Re: Residential Redevelopment

240 Mack

Detroit, Michigan

The existing 3 story multi-family residential property at 240 Mack Ave, Detroit, MI is intended to be redeveloped as a 21 unit apartment building including the addition of 4 new units on the third floor of the existing 2 story concrete block portion of building.

Z O RTI ELEVATION

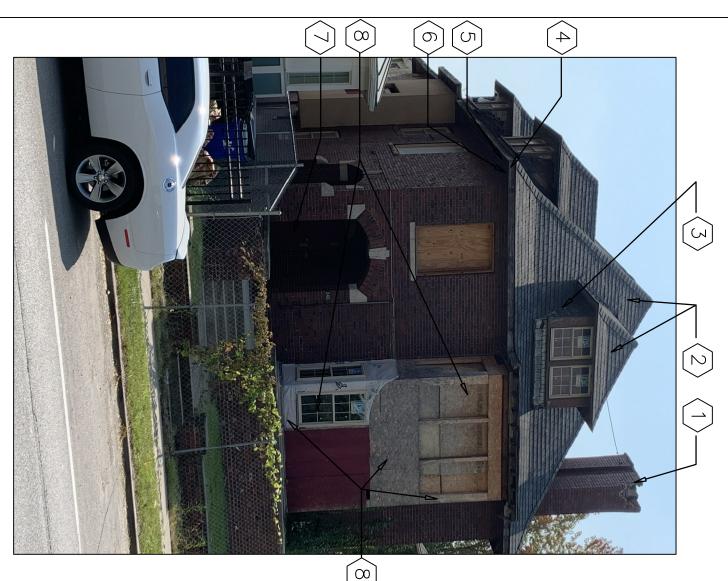
- 1. The existing chimney is to be repaired in place to its full original height. The decorative recessed panel is to be maintained (see east elevation) New precast concrete cap to match existing cap will

- 2. The existing finish roofing material (asphalt shingles) is to be removed complete. Any existing damaged roof sheathing is to be replaced. New 15# roofing felt, fully adhered ice and water shield,

- and new 30yr, Certainteed dimensional asphalt shingles are to be installed. Color: Driftwood clad wood windows (Pella architect series) with an 8 over 8 muntin pattern to match the original sheathing is to be replaced prior to reinstalling shingles. New dormer windows are to be aluminum dormers in order to keep original shingles on the most visible dormers. Any damaged wall the south elevation and used to fill and replace any damaged shingles on the north, east, and west Existing dormers are clad with slate shingles. Original shingles will be salvaged from the dormer on

- 4. Existing 1 x 6 fascia boards are to be scraped and painted. Any fascia boards that are damaged beyond repair are to be replaced with 1 x 6 pre-primed pine boards to match the existing fascia profile and painted to match.

- 5. Existing rafter tails are to scraped and painted.
- groove boards to match the existing soffit profile and painted to match.

7. The front door will be replaced with a preston patina craftsman rectangle door, with clear glass, 6. Existing soffit boards are 1×6 tongue and groove and shall be scraped and painted. Any soffit boards that are damaged beyond repair are to be replaced with ${f 1}$ x ${f 6}$ pre-primed pine tongue and
- painted. (see attached cut sheet) the transom window will be replaced with clear 1" insulated glass
- 8. The vinyl windows currently installed in the front bay will be removed. New aluminum clad wood windows (Pella architect series) with 6 over 1 muntin pattern to match the original windows.

9. The front bay windows will be trimmed with wood trim at the top and bottom. The middle section

- will be finished with a stucco / eifs system to match the east elevation. See detail A/A3.1 attached
- 10. All remaining windows will be replaced with aluminum clad wood windows (Pella architect series) with a 6 over 1 muntin pattern.

WEST ELEVATION

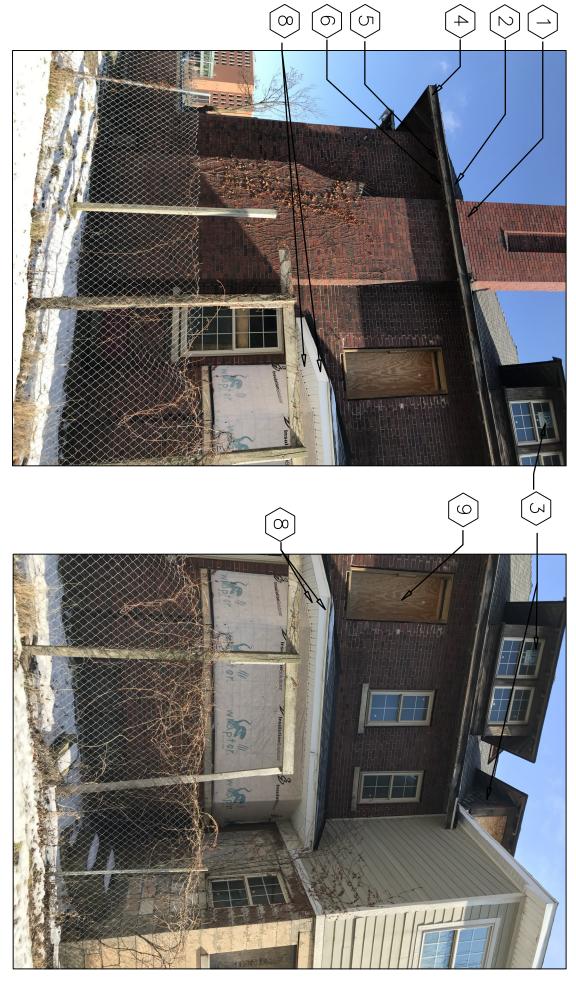
- 1. The existing chimney is to be repaired in place to its full original height. The decorative recessed panel is to be maintained (see east elevation) New precast concrete cap to match existing cap will be provided.

The existing finish roofing material (asphalt shingles) is to be removed complete. Any existing damaged roof sheathing is to be replaced. New 15# roofing felt, fully adhered ice and water shield, and new 30yr, Certainteed dimensional asphalt is to be replaced. New 15# roofing felt, fully adhered ice and water shield, and new 30yr, Certainteed dimensional asphalt shingles) is to be removed complete. Any existing damaged roof sheathing is to be replaced. New 15# roofing felt, fully adhered ice and water shield, and new 30yr, Certainteed dimensional asphalt shingles is to be removed complete. Any existing damaged roof sheathing is to be replaced. New 15# roofing felt, fully adhered ice and water shield, and new 30yr, Certainteed dimensional asphalt shingles. shingles are to be installed. Color: Driftwood

- original windows on the most visible dormers. Any damaged wall sheathing is to be replaced prior to reinstalling shingles. New dormer windows are to be aluminum clad wood windows (Pella architect series) with an 8 over 8 muntin pattern to match the Existing dormers are clad with slate shingles. Original shingles will be salvaged from the dormer on the south elevation and used to fill and replace any damaged shingles on the north, east, and west dormers in order to keep original shingless.

- 4. Existing 1 x 6 fascia boards are to be scraped and painted. Any fascia boards that are damaged beyond repair are to be replaced with 1 x 6 pre-primed pine boards to match the existing fascia profile and painted to match

- 5. Existing rafter tails are to scraped and painted.
- 6. Existing soffit boards are 1 x 6 tongue and groove and shall be scraped and painted. Any soffit boards that are damaged beyond repair are to be replaced with 1 x 6 pre-primed pine tongue and groove boards to match the existing soffit profile and painted to match.

- The vinyl windows currently installed on the front (historic portion) of the west elevation will be removed. New aluminum clad wood windows (Pella architect series) with 6 over 1 muntin pattern to match the original windows.

- 8. The aluminum soffit and fascias on the west bay window will be removed. They will be replaced with new 1 x 6 preprimed wood fascias to match existing profile. The soffit will be replaced by 1 x 6 tongue and groove soffit boards to match the

- 9. The existing door opening will be reduced in size and infilled with brick to match existing to accomodate a window that matches those adjacent to it.

WEST ELEVATION, CON'T

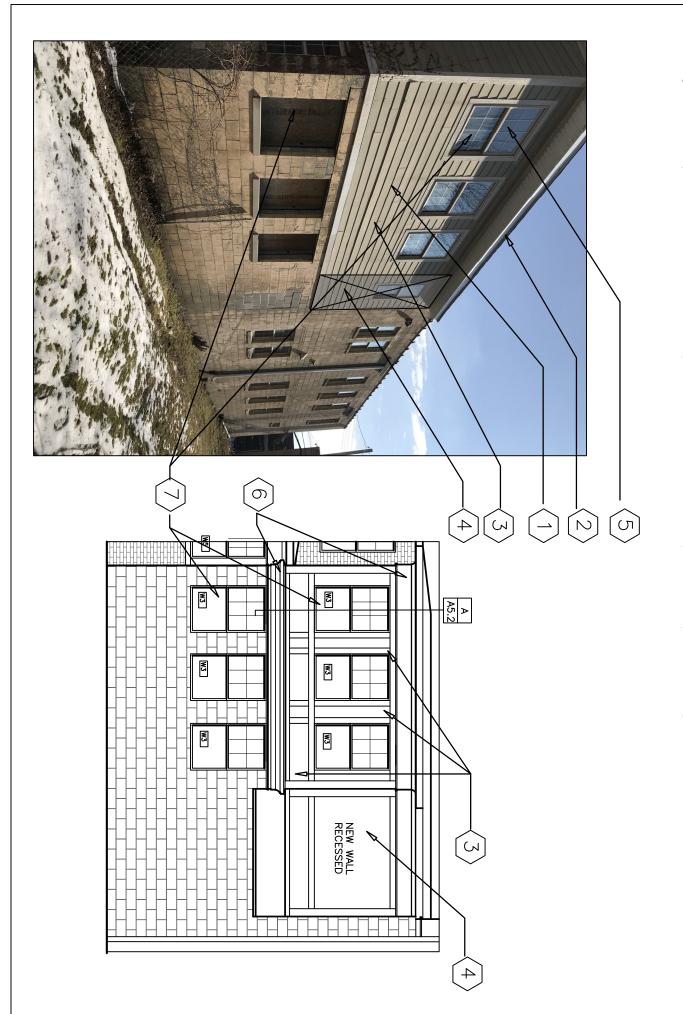
- 1. All existing lap siding is to be removed complete with all corner and window trims.
- 2. The existing shed roof will be removed complete with all finish roofing, rafters, soffits and fascias. A new low slope, nearly flat roof will be installed per detail A/A5.2

- Existing walls will be trimmed with 1 x wood trim and painted to match original porch walls as closely as possible. See detail A/A5.2
- 4. The existing portion of the wall shown as shaded below will be removed, and setback 24" from it's current location in order to restore the 3 sided massing of the original second floor porch (see attached photo)

5. The vinyl windows currently installed on the front (historic portion) of the west elevation will be removed. New aluminum clad wood windows (Pella architect series) with 6 over 1 muntin pattern to match the original windows.

- 6. Wood crown trims at line of first floor are to be restored with new crown. See detail A/A5.2 for profiles.

7. All existing windows at historic porch section shown are to be removed and replaced with new aluminum clad wood windows (Pella architect series) with 6 over 1 muntin pattern.

WEST ELEVATION, SOUTH ELEVATION

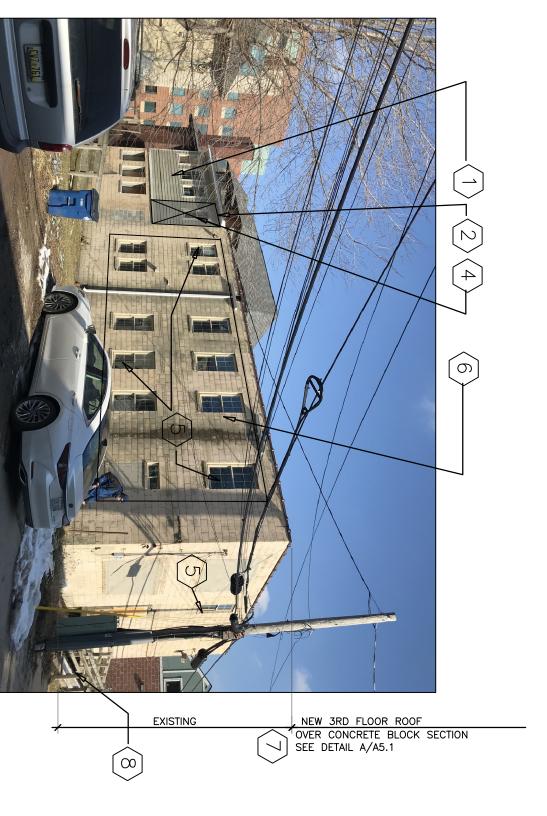
- 1. All existing lap siding is to be removed complete with all corner and window trims.
- . The existing shed roof will be removed complete with all finish roofing, rafters, soffits and fascias. A new low slope, nearly flat roof will be installed per detail A/A5.2

- The existing portion of the wall shown as shaded below will be removed, and setback 24" from it's current location in order to restore the 3 sided massing of the original second floor porch Existing walls will be trimmed with 1 x wood trim and painted to match original porch walls as closely as possible. See detail A/A5.2

- 8. The existing ADA access ramp will be removed and replaced. See detail 1+2 A/A5.3
- 5. The aluminum windows currently installed on the concrete block portion of the west elevation, shown below will remain.

6. Existing concrete block walls are to be scraped and painted.
 7. a new hipped roof structure will be built over the existing concrete block wall section to match slope of existing historic roof. see detail A/A5.1

Ш ⊅sT ELEVATION

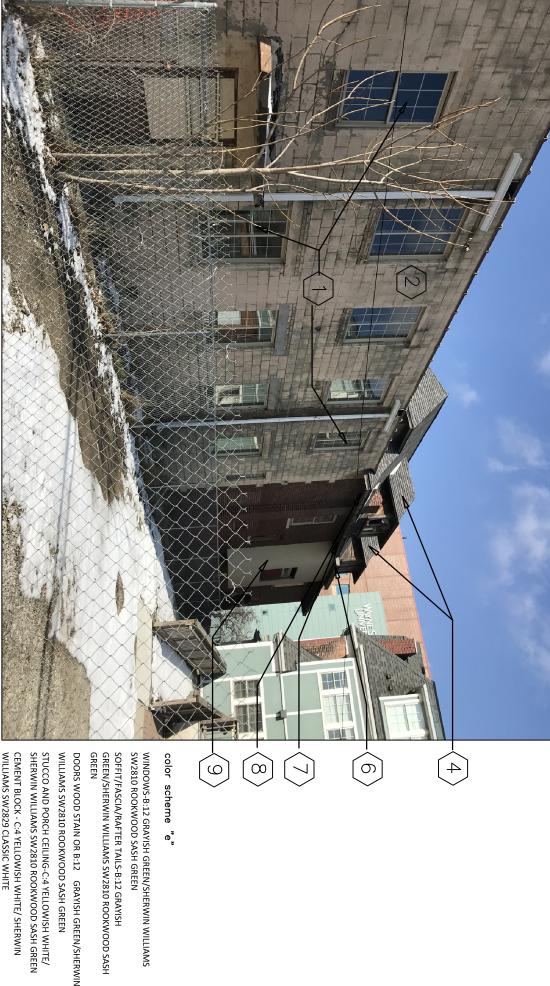
- 1. The aluminum windows currently installed on the concrete block portion of the east elevation, shown below will remain.
- Existing concrete block walls are to be scraped and painted. a new hipped roof structure will be built over the existing concrete block wall section to match slope of existing historic roof, see detail A/A5.1

- 4. The existing finish roofing material (asphalt shingles) is to be removed complete. Any existing damaged roof sheathing is to be replaced. New 15# roofing felt, fully adhered ice and water shield, and new 30yr, Certainteed dimensional asphalt shingles) is to be removed complete. Any existing damaged roof sheathing is to be replaced. New 15# roofing felt, fully adhered ice and water shield, and new 30yr, Certainteed dimensional asphalt shingles) is to be removed complete. shingles are to be installed. Color: Driftwood

- Existing dormers are clad with slate shingles. Original shingles will be salvaged from the dormer on the south elevation and used to fill and replace any damaged shingles on the north, east, and west dormers in order to keep original shingles on the most visible dormers. Any damaged wall sheathing is to be replaced prior to reinstalling shingles. New dormer windows are to be aluminum clad wood windows (Pella architect series) with an 8 over 8 muntin pattern to match the original windows.

- 6. Existing 1 x 6 fascia boards are to be scraped and painted. Any fascia boards that are damaged beyond repair are to be replaced with 1 x 6 pre-primed pine boards to match the existing fascia profile and painted to match

- Existing rafter tails are to scraped and painted.
- 8. Existing soffit boards are 1 x 6 tongue and groove and shall be scraped and painted. Any soffit boards that are damaged beyond repair are to be replaced with 1 x 6 pre-primed pine tongue and groove boards to match the existing soffit profile and painted to match.

- Existing eifs finish at the stairwell bay is to remain
